This decision document presents the selected remedial action and contingent remedial action for the Albion-Sheridan Township Landfill Site, Albion, Michigan, which were chosen in accordance with the Comprehensive Environmental Response, Compensation, and Liability Act (CERCLA) of 1980, as amended by the Superfund Amendments and Reauthorization Act (SARA) of 1986, and, to the extent practicable, the National Oil and Hazardous Substances Pollution Contingency Plan (NCP). This decision is based on the administrative record for this Site. The State of Michigan concurs with this decision.

The Albion-Sheridan Township Landfill site (the "site") is an inactive landfill located at 29975 East Erie Road approximately one mile east of Albion, Michigan on the eastern edge of Calhoun County. The landfill is approximately 18 acres in area and its boundaries are shown in **Figure 1**.

FIGURE 1

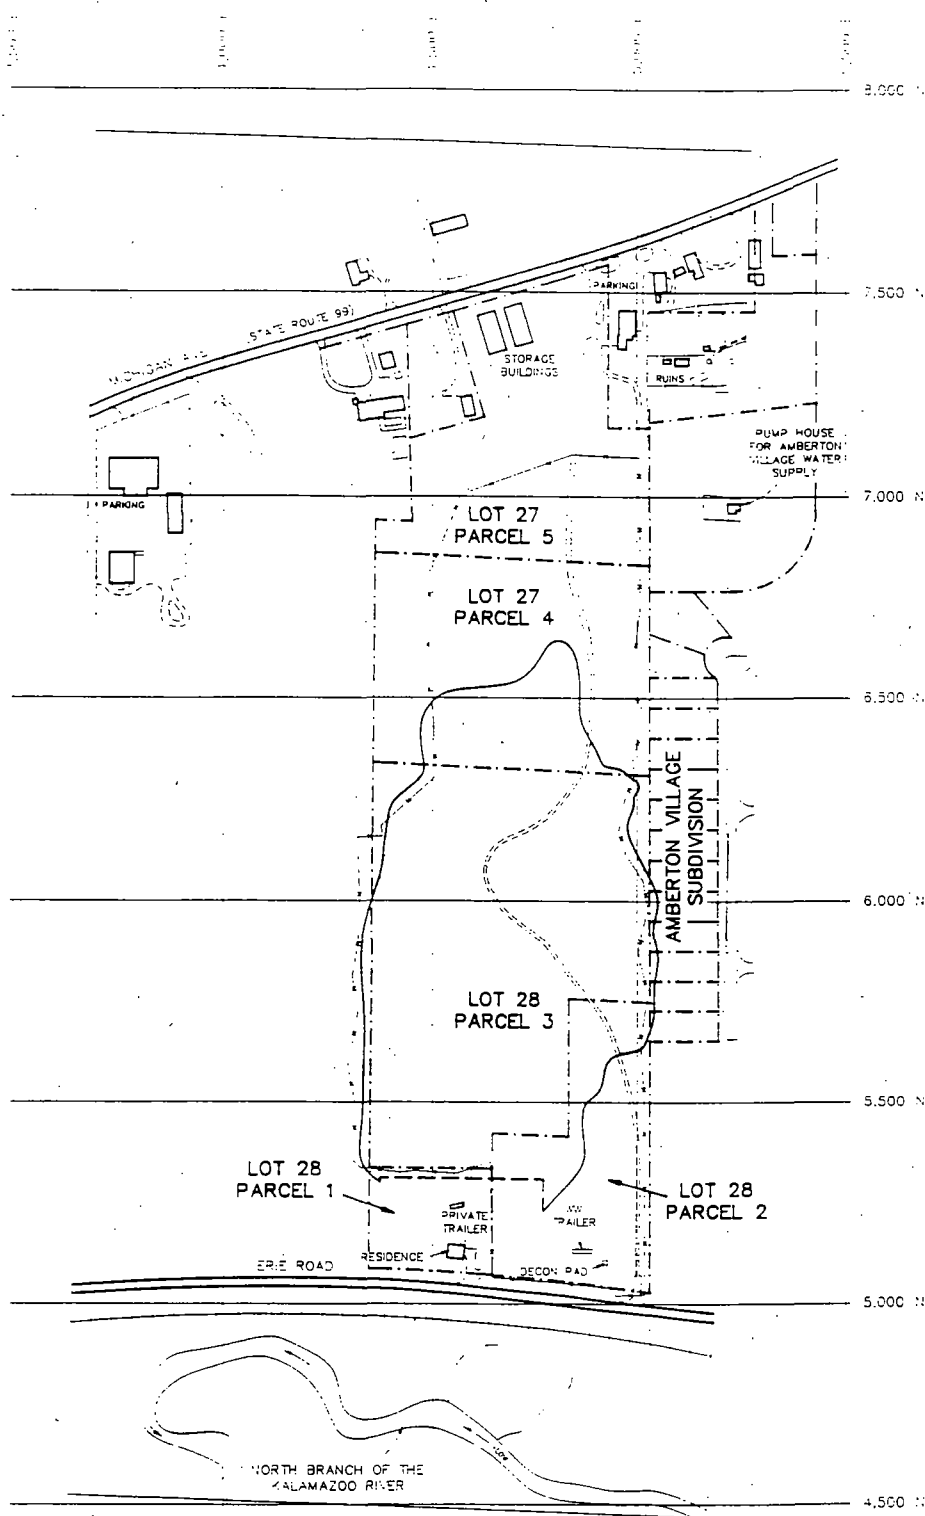
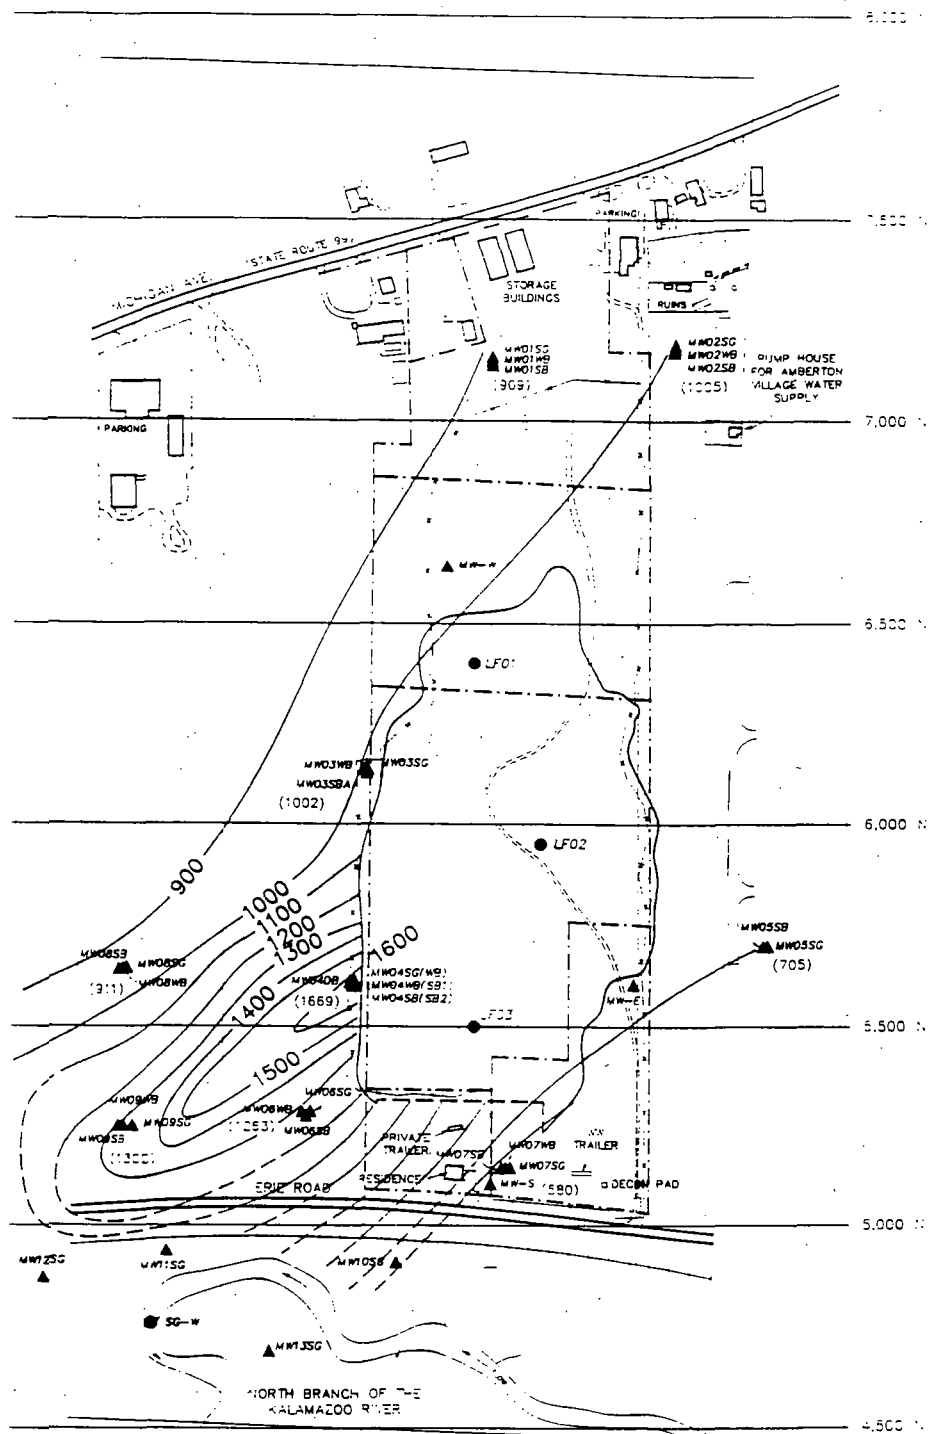
The entire landfill waste mass shown on Figure 1 will be capped. Site preparation and layout will be completed to re-route surface water drainage away from the capped area.

Waste on the east edge of the landfill will be consolidated towards the west so that the east boundary of the landfill cap and any perimeter road needed for maintenance is contained on Lot 28 (Figure 1). Waste on the south edge of the landfill will be consolidated so that the south boundary of the landfill cap and any perimeter road needed for maintenance is contained on Lot 28, parcel 3 and that portion of Lot 28, parcel 2 north of a line extending due east from the north boundary of parcel 1. If Lot 28, parcels 1 and 2 are instead acquired, consolidation of the south edge of the landfill will not be necessary. Any property acquisition will be done in compliance with the Uniform Relocation Assistance and Real Property Acquisition Policies Act of 1970.

FIGURE 4  
ARSENIC  
ISOCONCENTRATION MAP  
SHALLOW BEDROCK

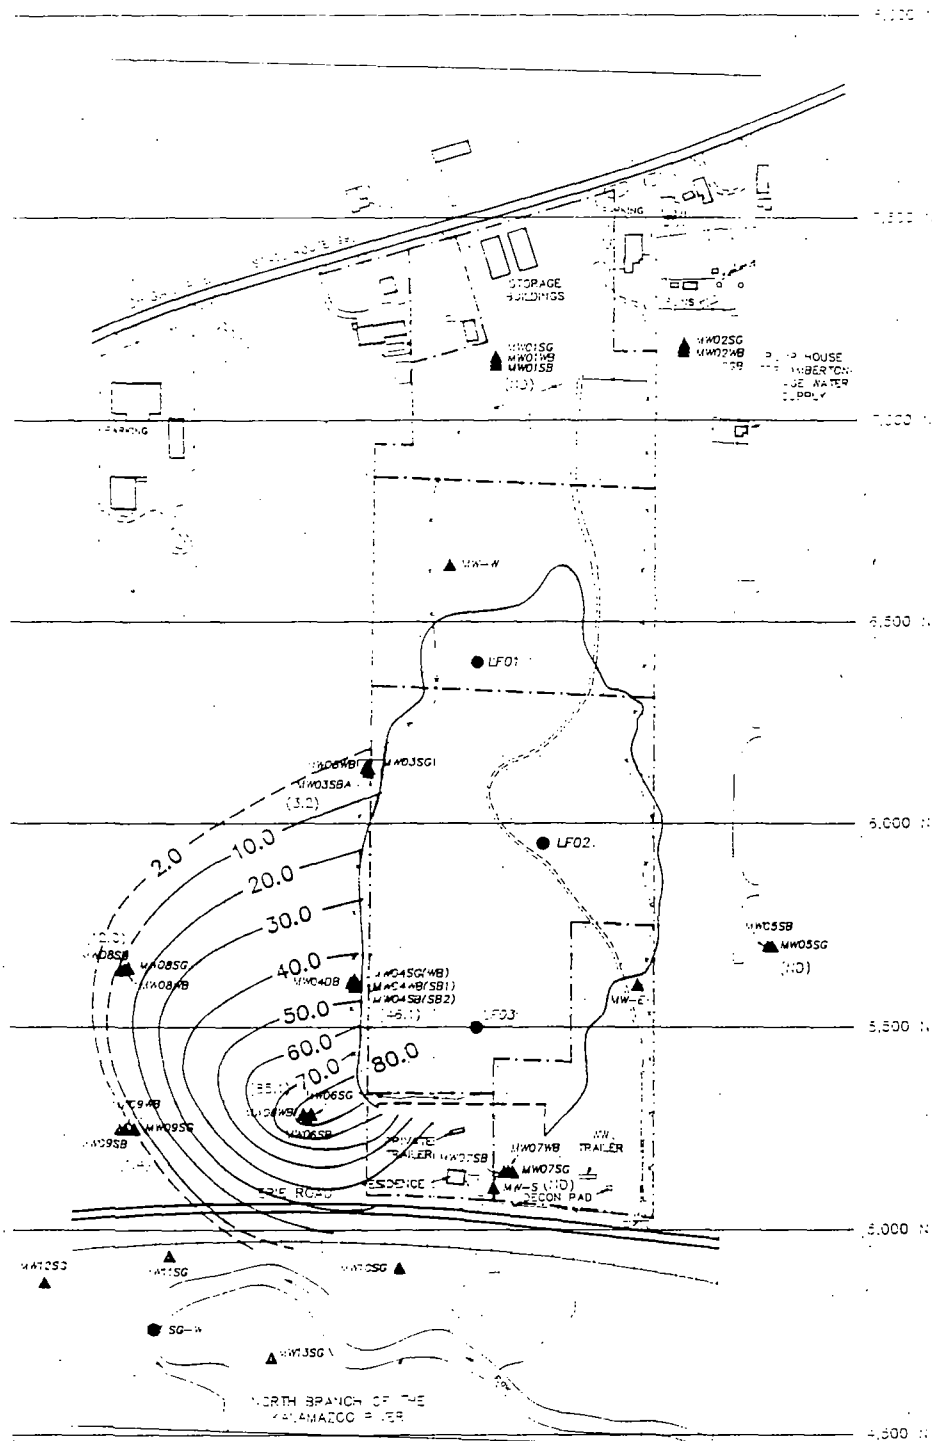
COMMENT: Ms. Sally Ammerman asks how close to the landfill new drinking waters wells would have to be, to be at risk.

RESPONSE: This ROD requires the imposition of deed restrictions or local ordinances prohibiting domestic use water wells which draw water from the arsenic contaminant plume shown on Figure 4. This area extends approximately 600 feet to the southwest of the landfill. Outside of this area, arsenic is at or below the natural background level in the region. Water wells close to the plume boundary (defined as 2 ug/l arsenic) shown on Figure 4 may draw water from the plume if they are very shallow; deeper wells, such as the existing private well immediately south of the landfill, may not be affected because they are deeper than the plume.
